REV Date Drawn by: -Checked by: -Status Purpose of Issue For Information drawing stage client McDonald's Restaurant's Ltd store 4 HARBEN PARADE,

**EXISTING AND PROPOSED ELEVATIONS**

SWISS COTTAGE

## FRONT ELEVATION & PART PLAN

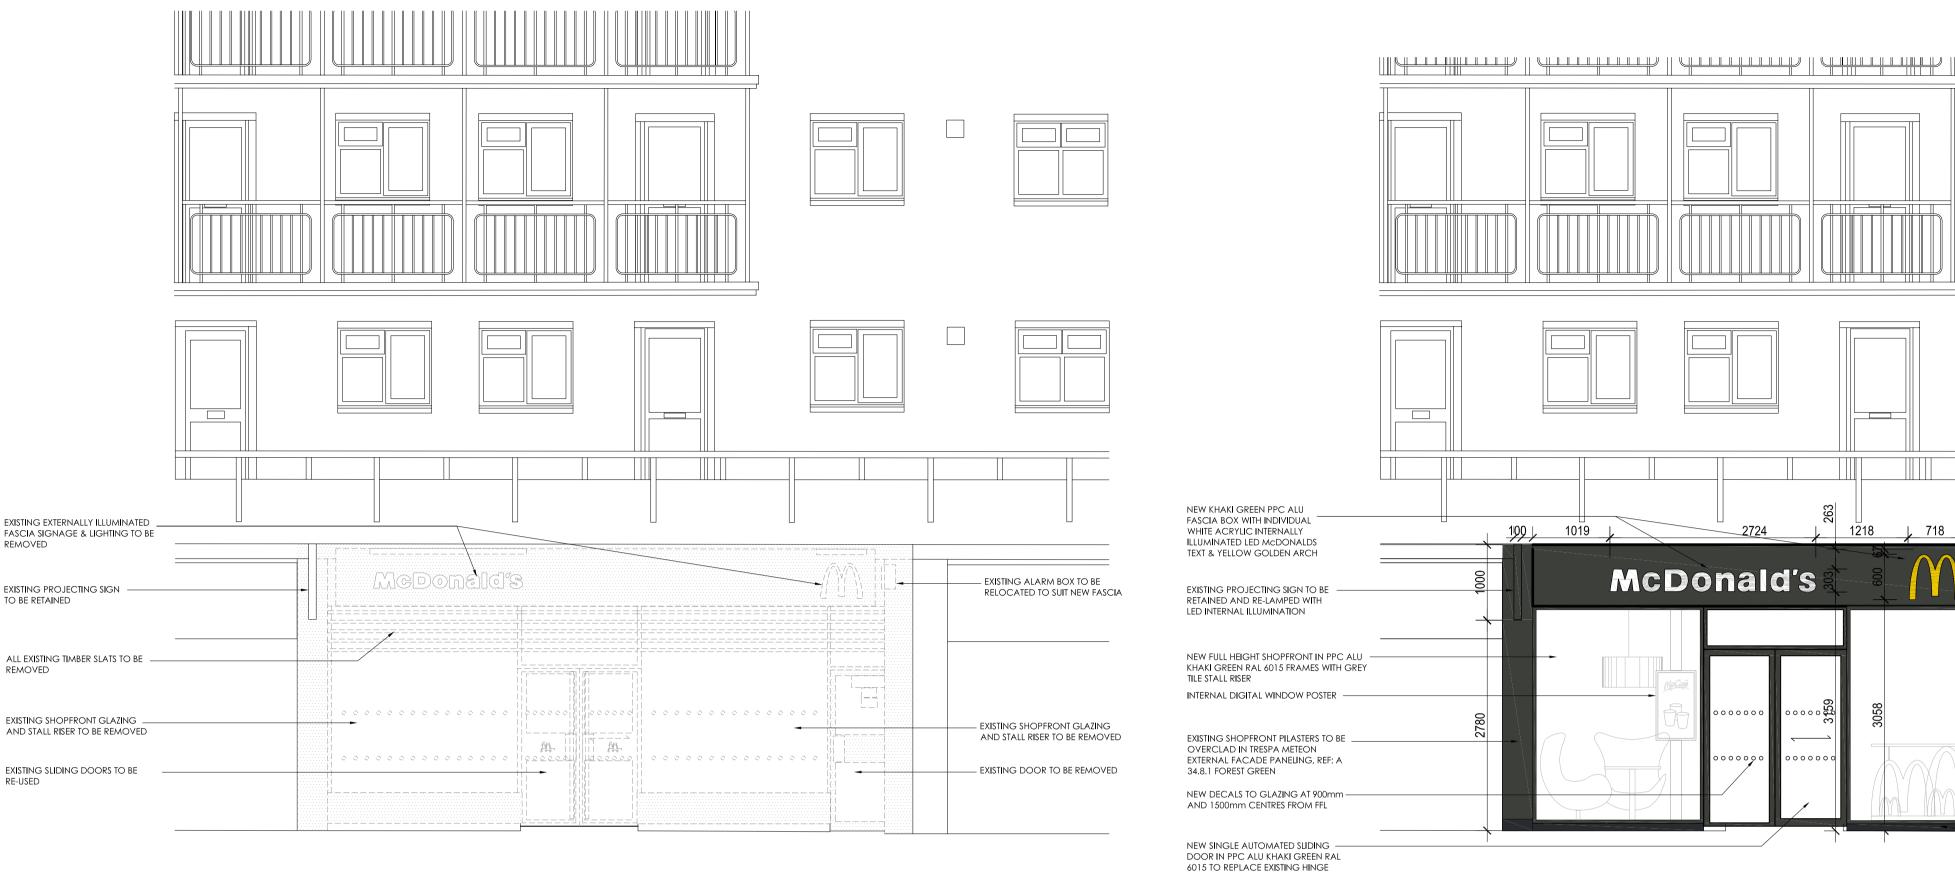
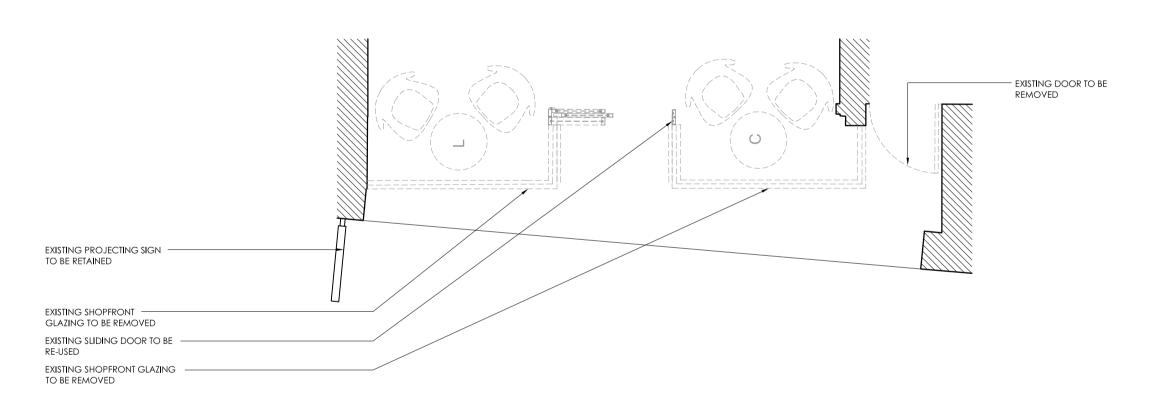
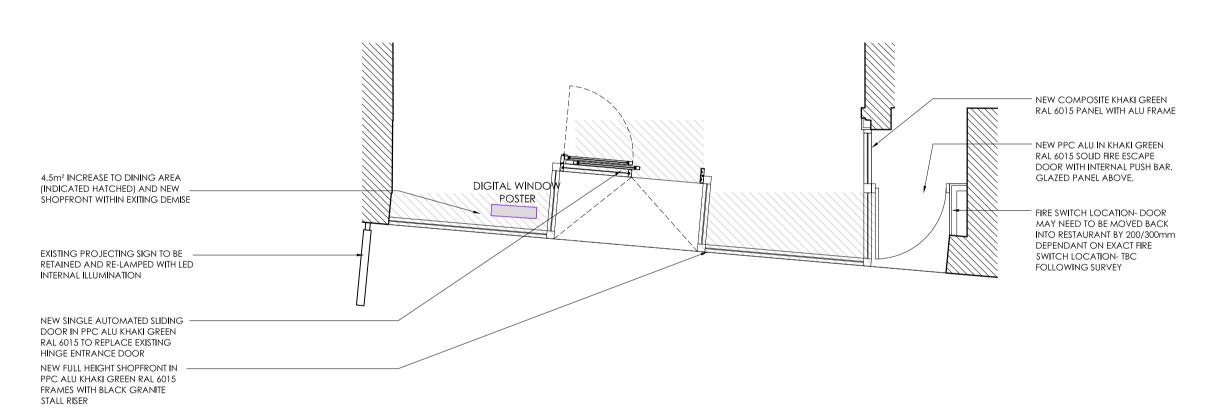
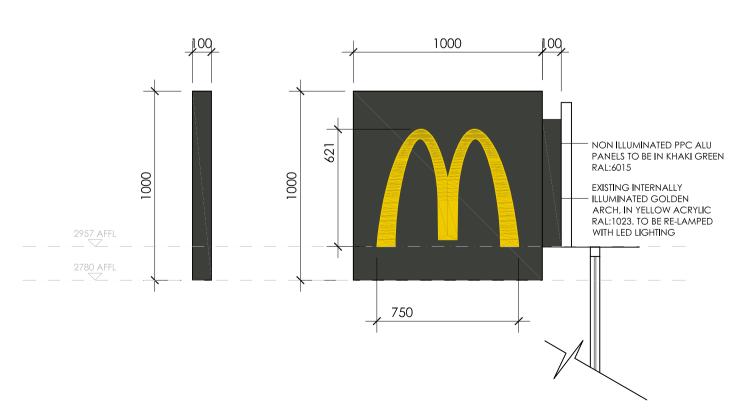
FIRST FLOOR OF BUILDING INDICATED ON PROPOSED

ELEVATION. ALU BOX SIZE INCREASED TO FILL FASCIA

TRESPA PANELING TO PILASTERS & UPDATED TO NEW

MOE door to be solid. location may vary

MOE door to RHS of shopfront brought

Shopfront area reduction indicated.

Shopfront glazing line moved forward, as PM
